CENTRAL VALLEY FLOOD MANAGEMENT PLANNING PROGRAM

Errata to the Public Draft

2012 Central Valley Flood Protection Plan

Volume II – Attachment 7

25. Attachment 7 – Plan Formulation Report, Section 7.6.2, Page 7-77, Figure 7-34, and 7-35.

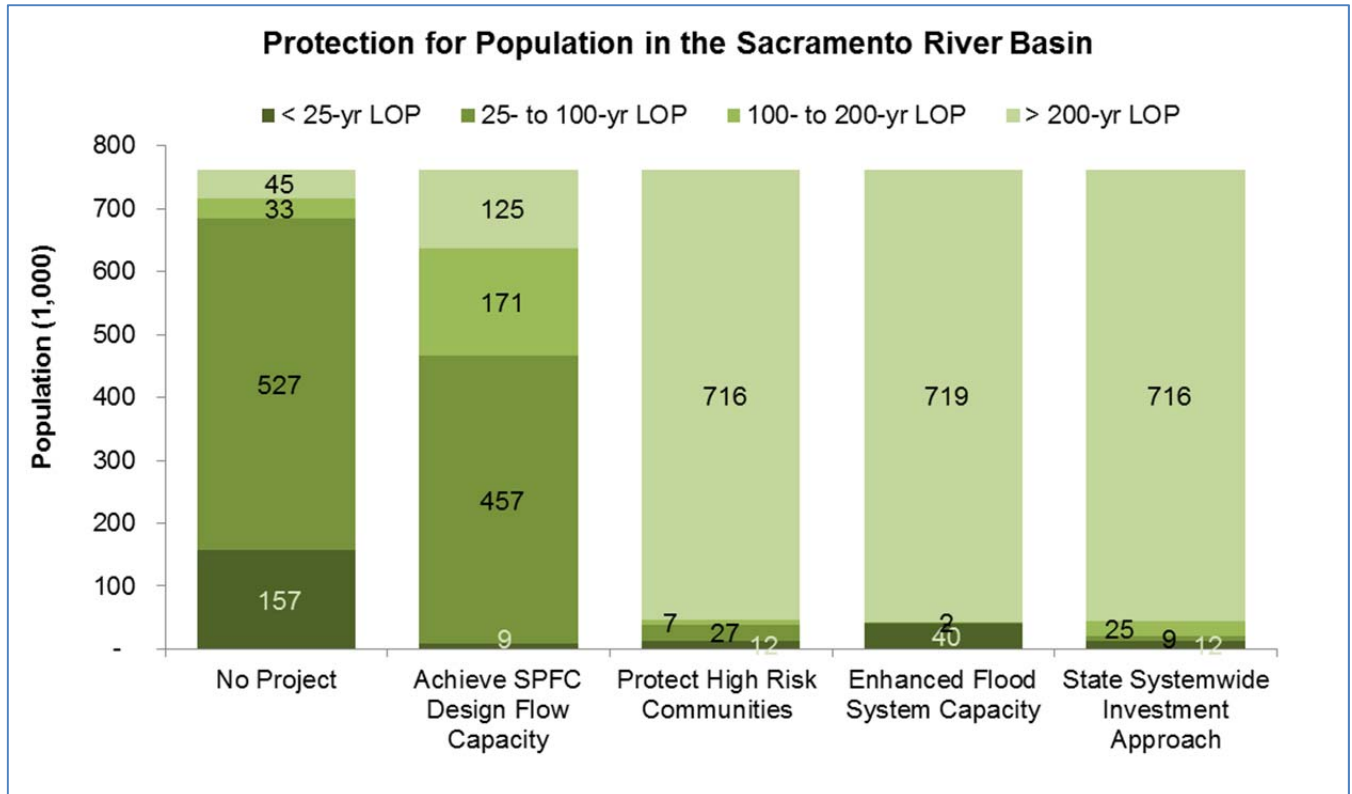
Replace Figure 7-34 “Protection for Population in Sacramento River Basin” with the following:

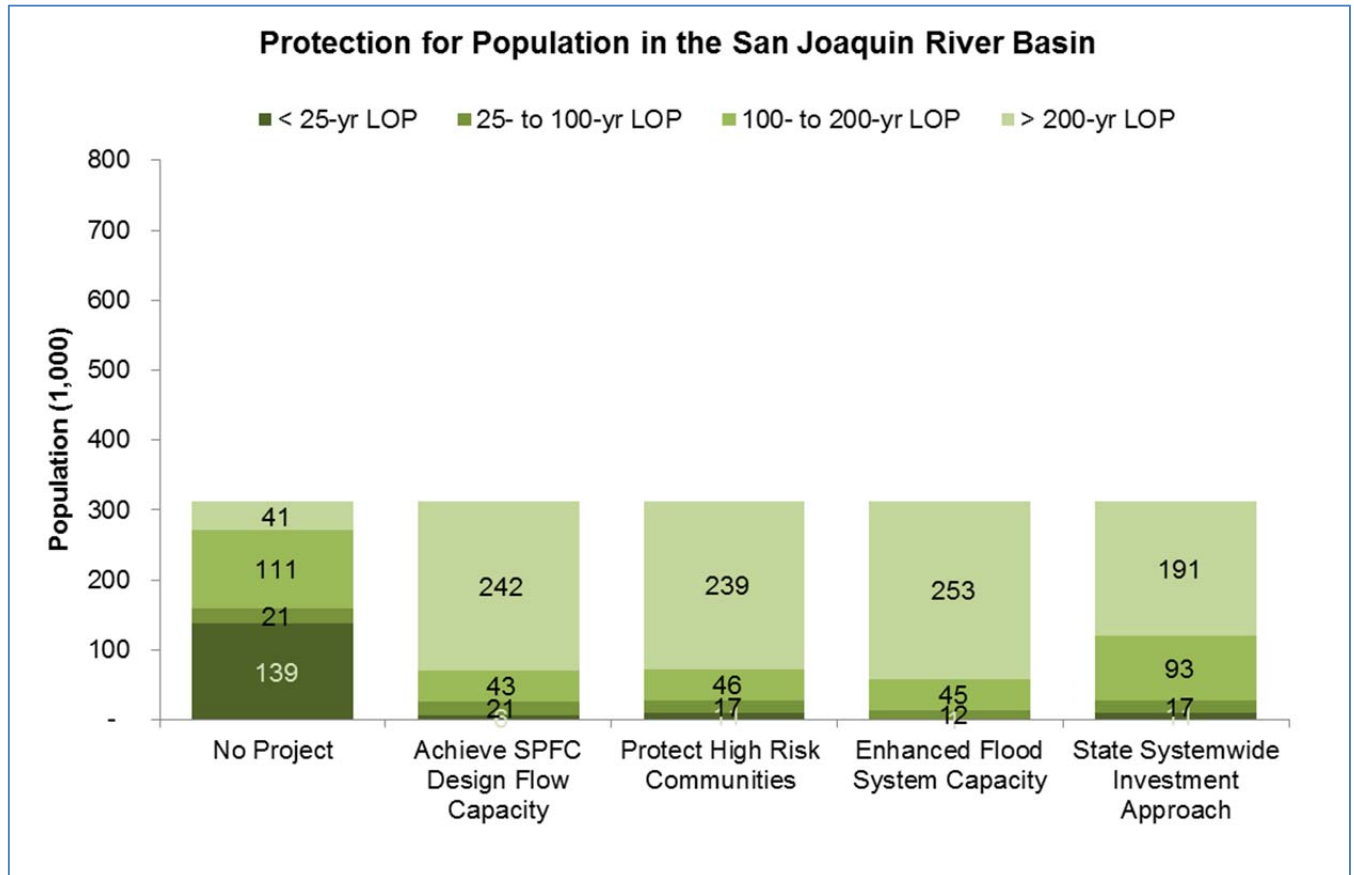
Replace Figure 7-35 “Protection for Population in San Joaquin River Basin” with the following:

30. Attachment 7 – Plan Formulation Report, Section 7.6.2, Page 7-77, Figure 7-34, and 7-35.

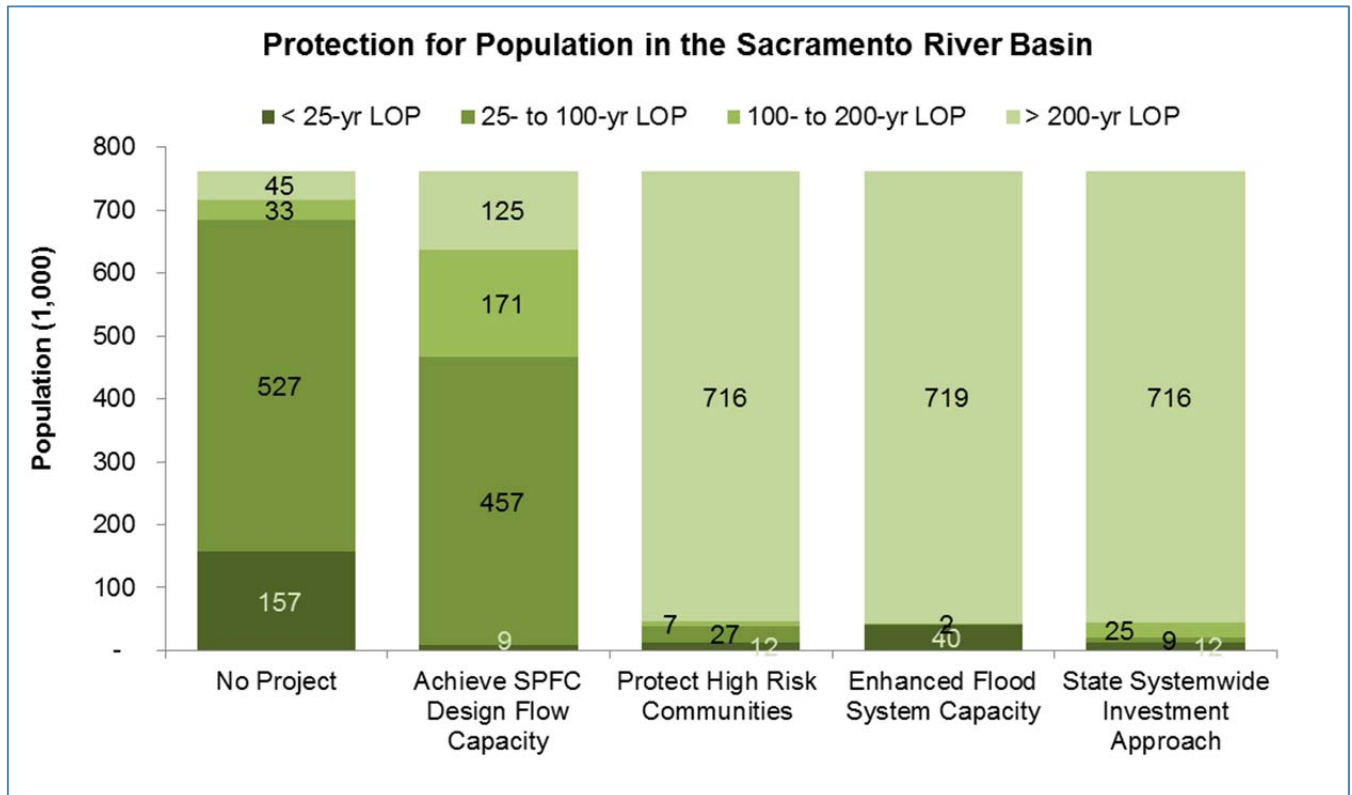
Replace Figure 7-34 “Protection for Population in Sacramento River Basin” with the following:

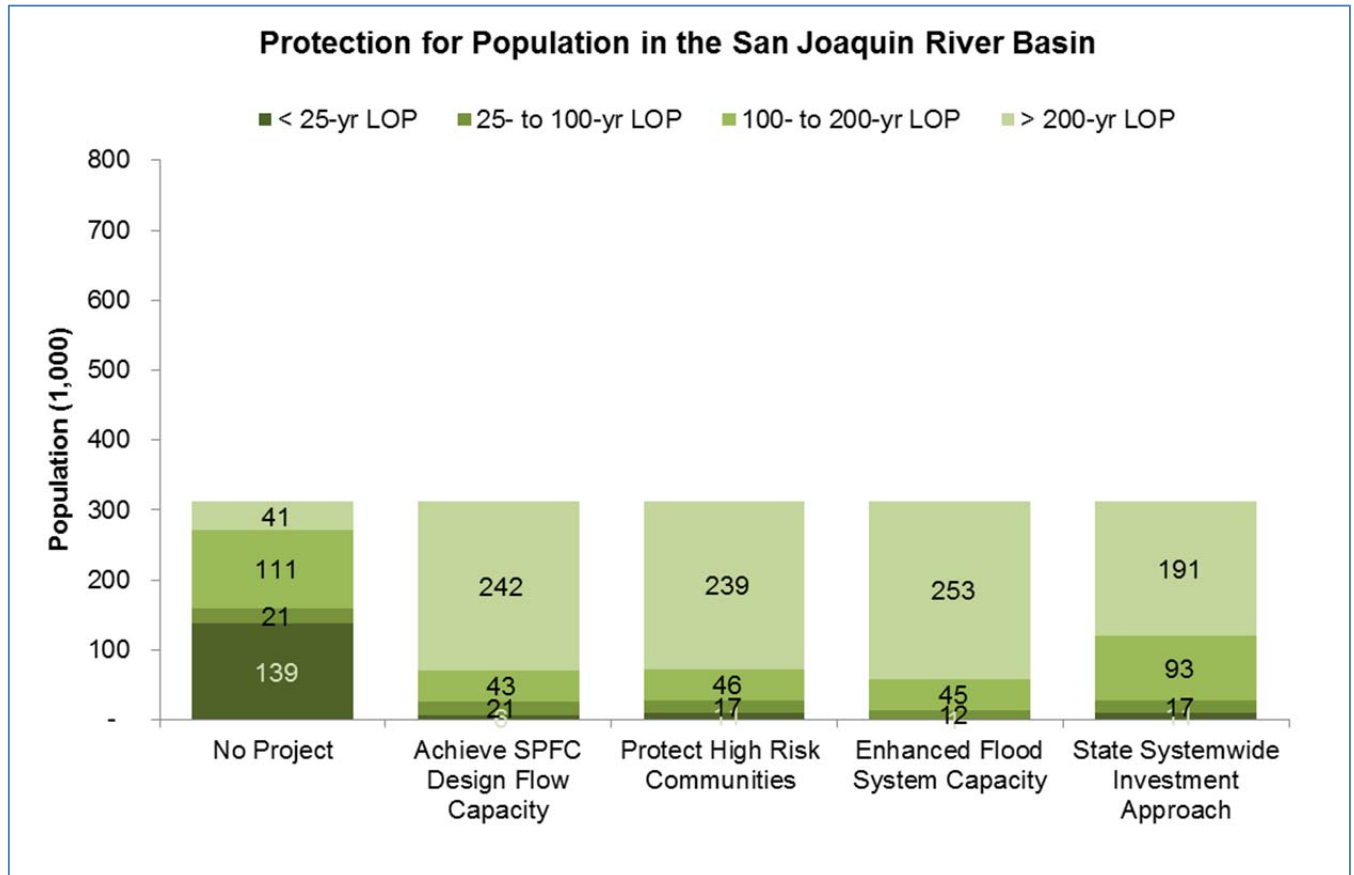
Replace Figure 7-35 “Protection for Population in San Joaquin River Basin” with the following:

Figure 8-1. State Systemwide Investment Approach – Sacramento River Basin Major Capital Improvements **under Consideration**

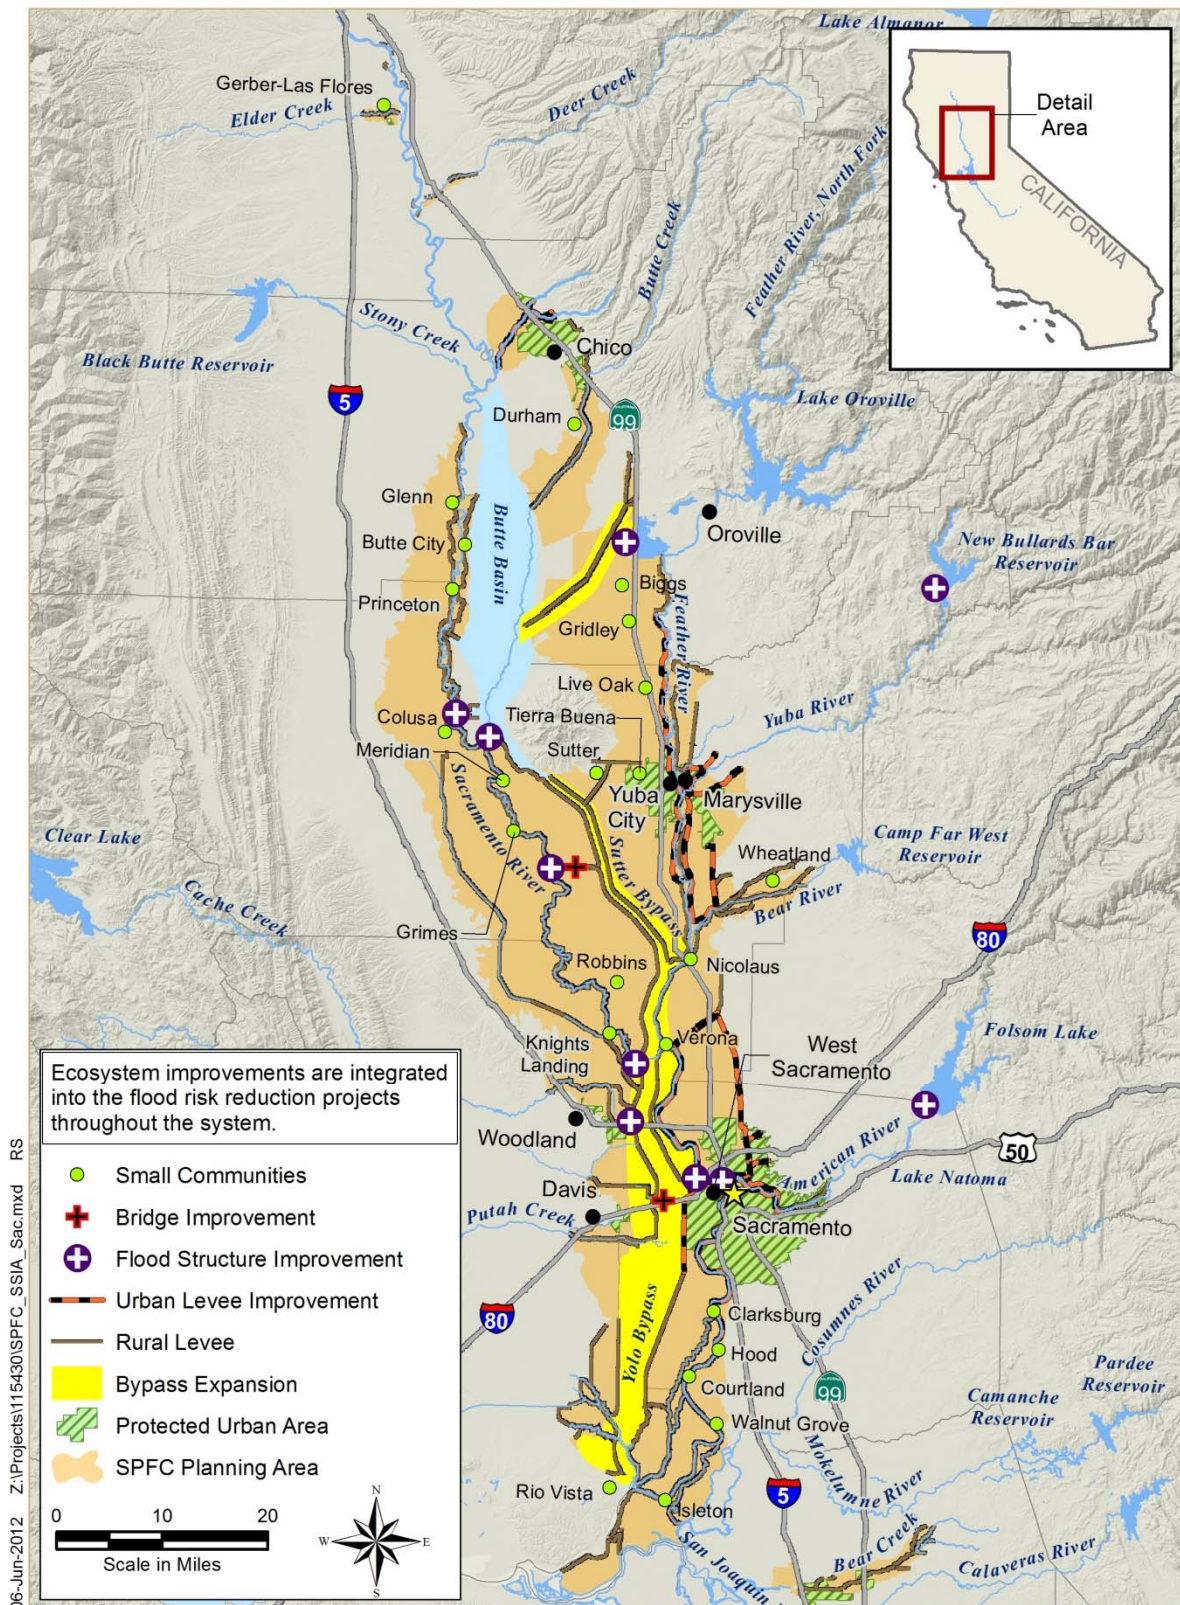
Figure 8-1 and Figure 8-2 have revised titles and are replaced by the following, respectively:
